Impedance Guidelines for the SPS

Proof of concept in the SPS

- Installation of a Fabry-Perot cavity in LSS6 of the SPS
- Requires an optical cavity with a small angle to the beam on the order of a few degrees (Long cavity) $s=6285.155$ m to $s=6291.412$ m is proposed
- This will lead to several possible impedance issues

Impedance Consequences

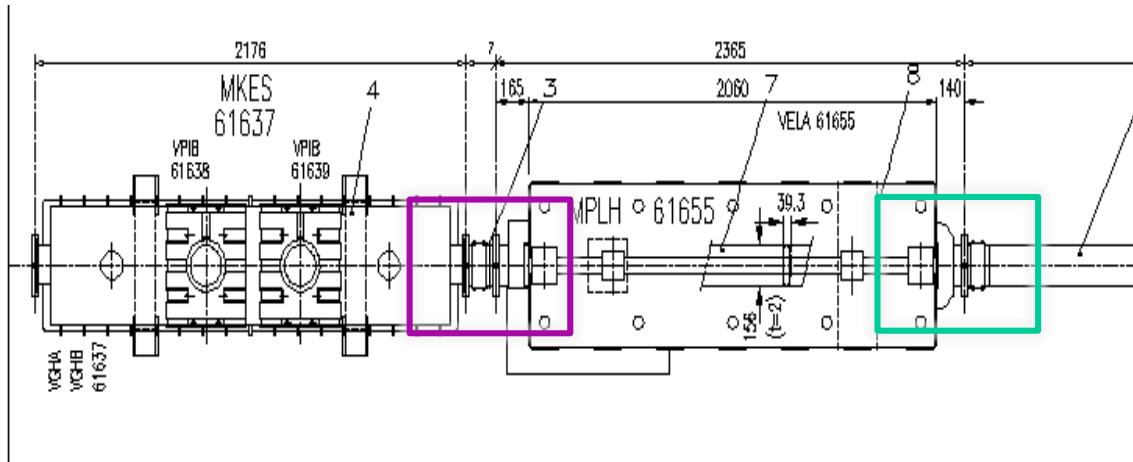
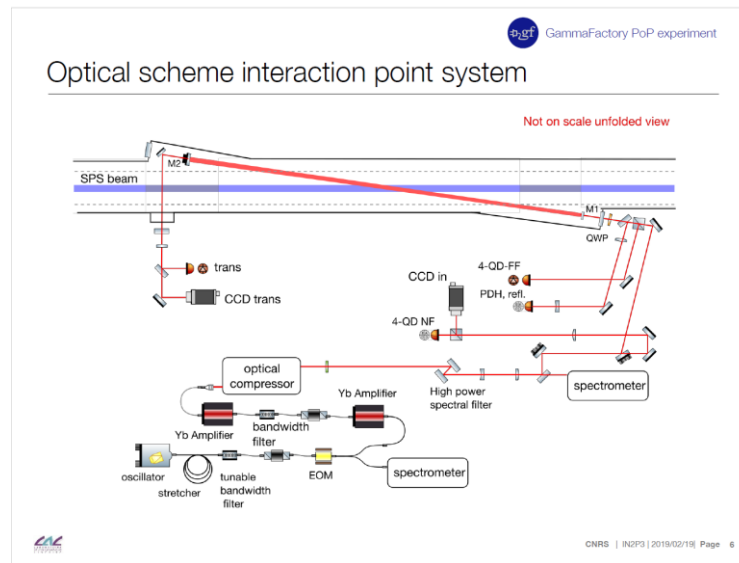
- Relocation of the MPLH which has a flat beam pipe poses issues
- Between the MKES and the MPLH a cavity is created which will give an impedance contribution
- This side would require the installation of a dedicated shield between the MKES and the MPLH which in all likely hood will also encompass a bellows between them
- In addition this creates an electrical connection from the MKES which needs investigation
- The step out is also not ideal and should be tapered on the down stream end

As the POP equipment length has been reduced the MPLH will not move now.

The Fabry-Perot Cavity Itself

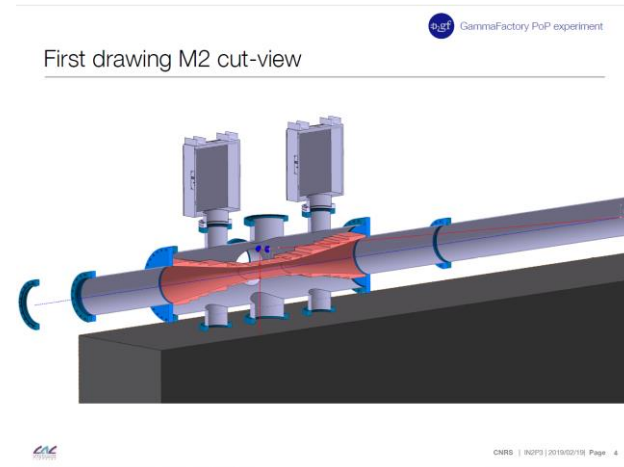
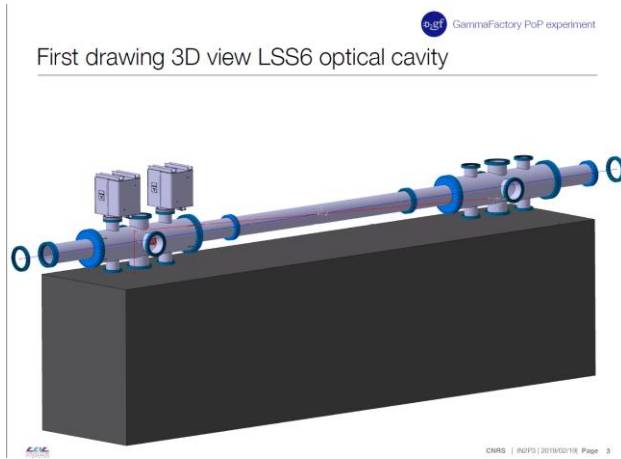
- Ideally any device which is not a requirement for the LHC or FT beams should be transparent
- In this location that would mean the ideal case would be to maintain the current 156 mm internal diameter if possible
- Detailed guidance can only be given once the design is in a more advanced state

Proposed Design

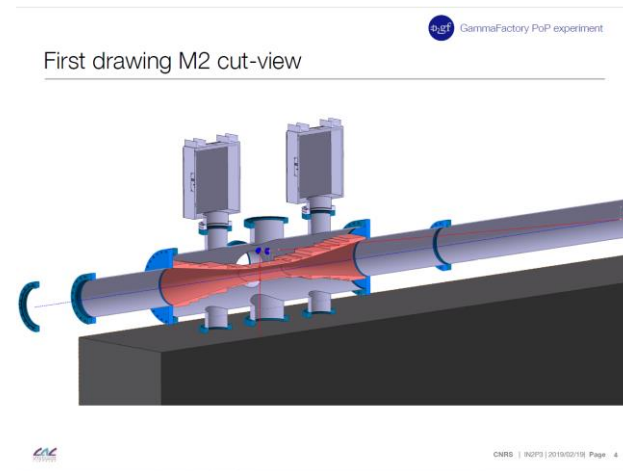
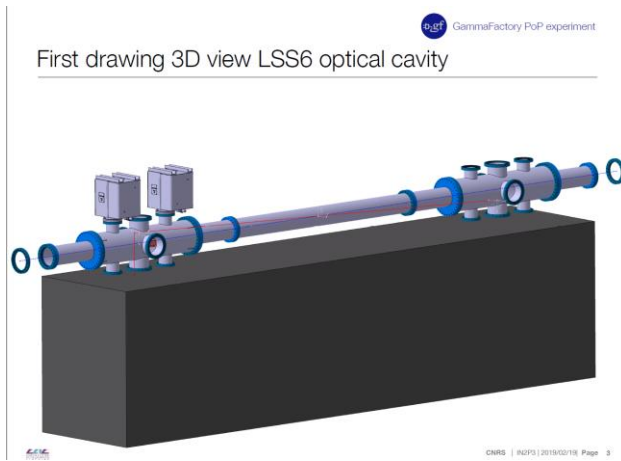
- Introduction of tapers with an angle less than 15 degrees is helpful for impedance
- Shields will require holes for pumping (Check with TE/VSC)
- The current layout will create a long and hopefully inefficient cavity between the two tanks (to be confirmed)
- Additional bellows for alignment may also be required at each connection point (TE/VSC to advise)

Alternative (1/2)

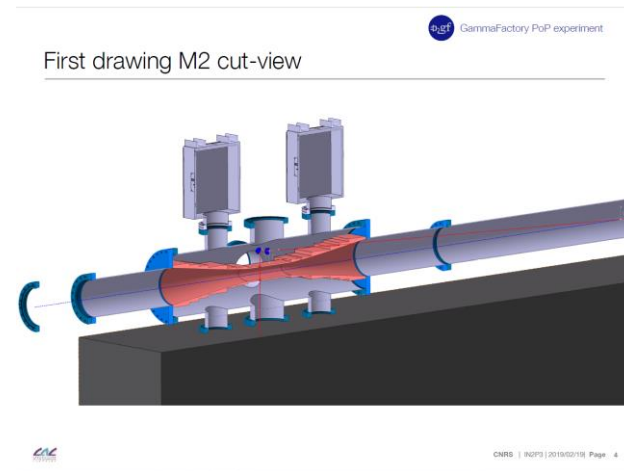
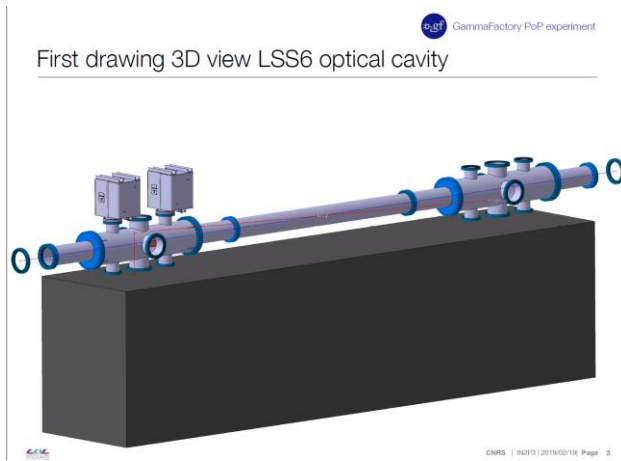
- Maintain the 156 mm round aperture
- Have tank with the additional volume for the primary mirrors attached to the 156 mm pipe with only the openings for the laser and for pumping - **All of this inside primary vacuum**
- The laser input and output can all be outside of the vacuum with an optical array and window used to allow it to reach the primary mirrors
